# Access Compliance Report

## Public Rights-of-Way

Intersection ID: N/A	Main Street: GREY_SQUIRREL_CT	Cross Street: WILLOW_TREE_LN	Location: E
ADA ID: 50E82A6706FE	Ramp Type: BlendTrans2	Initial Pass/Fail: Pass	Overall Compliance: No
		Severity Score: 15

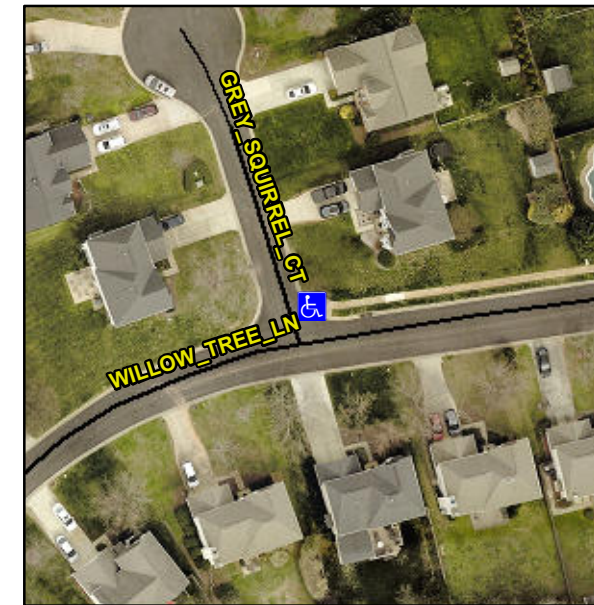
**R305, R304.5.4**

Compliance	Description	Data	Compliance	Description	Data
N/A	Ramp Length (in)	96.0	Yes	BlendTrans Slope (%)	2.8
Yes	Ramp Width (in)	69.0	Yes	BlendTrans XSlope (%)	0.9
N/A	Flare Type LT	Sloped	N/A	Flare Type RT	Sloped
N/A	Flare Slope LT (%)	0.7	N/A	Flare Slope RT (%)	2.4
N/A	Flare Traversable LT?	No	N/A	Flare Traversable RT?	No
N/A	Landing Length (in)	N/A	No	DWS Provided?	No
N/A	Landing Width (in)	N/A	N/A	DWS Contrast?	No
N/A	Landing Slope (%)	N/A	N/A	DWS Length (in)	N/A
N/A	Landing X Slope (%)	N/A	N/A	DWS Full Width?	No
N/A	Landing Curb? (Y/N)	No	N/A	DWS Offset (in)	N/A
N/A	Shared Landing?	No			
Yes	Gutter Ponding?	No	No	Gutter Slope (%)	12.7
Yes	Gutter Lip Ht (in)	0.0	Yes	Gutter X Slope (%)	0.5
N/A	Painted X Walk1?	No	N/A	Painted X Walk2?	No
	X Walk 1 Direction	To W		X Walk 2 Direction	To S
	X Walk 1 Width (in)	N/A		X Walk 2 Width (in)	N/A
	X Walk 1 Slope (%)	1.3		X Walk 2 Slope (%)	2.3
	X Walk 1 X Slope (%)	1.5		X Walk 2 X Slope (%)	1.8

**Install Detectable Warning System.  
Remove & Replace Gutter.**
